PUBLIC INTEREST REVIEW FOR GROUNDWATER APPLICATIONS

SUBJECT: Application G- 17689 Supersedes review of _____
Date of Review(s)

A. GENERAL INFORMATION: Applicant's Name: K-Diamond, Inc. County: Baker

D1. Well #: 1 Logid: No Log

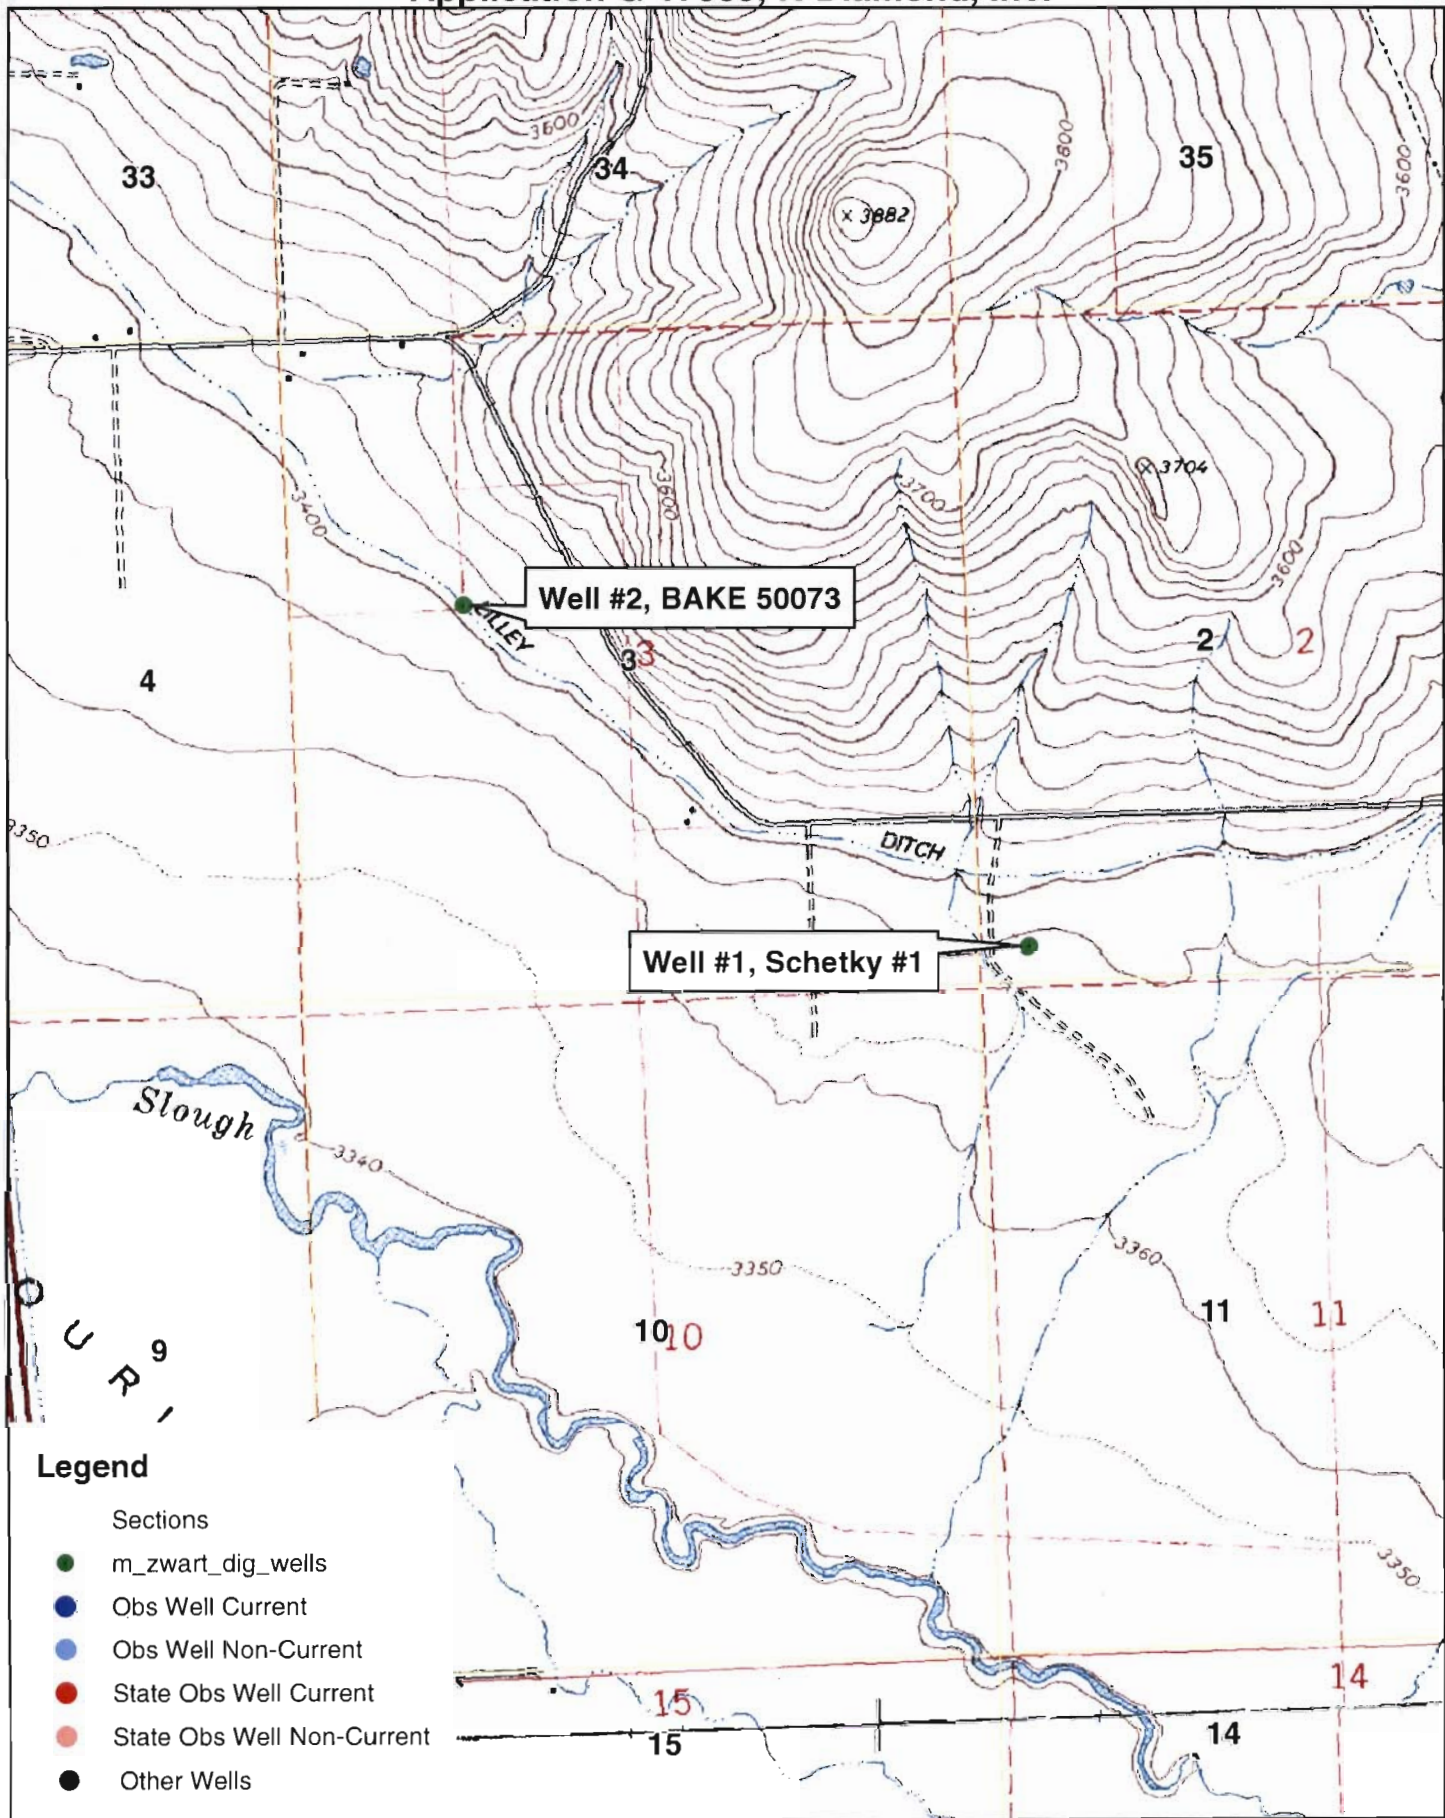
- a. review of the well log;
- b. field inspection by _____;
- c. report of CWRE _____;
- d. other: (specify) No well seal.

D3. **THE WELL construction deficiency or other comment is described as follows: The applicant has previously discussed this issue with Ivan Gall and Bob Maynard. The applicant is aware that this well will need to be sealed to the Department's standards prior to obtaining a permit.**
